Attention: ABS wire routing

Models: 2016 Toyota Tacoma 4WD, Tacoma PreRunner 2WD

Affected Pro Comp Kit numbers:

57397B, K5089B

Figure A

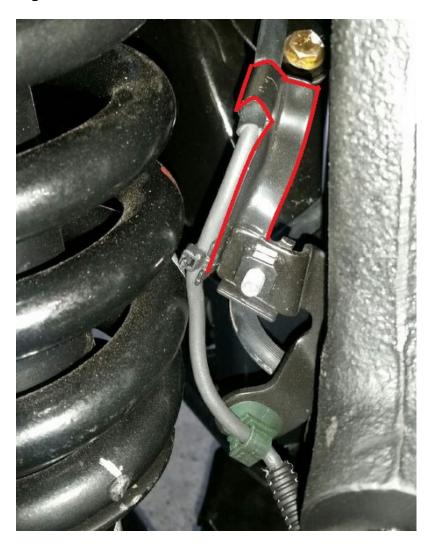
Overview: In monitoring our technical service inquiries we have identified the potential for routing issues that allow the ABS wire to be pinched between its retention bracket and the coil spring at full steering lock. **See figure A**

Solution: The following instruction is offered to improve the ABS wire routing for new lift installations. Carefully remove the ABS wire from its upper retention bracket, outlined in red in **figure A**. Remove the upper retention bracket and secure the ABS wire with an Adele clamp using the previously removed bolt. See **figure B**. Repeat these steps for the other side. Make certain there is no pinching, rubbing, or stretching of the ABS wires.
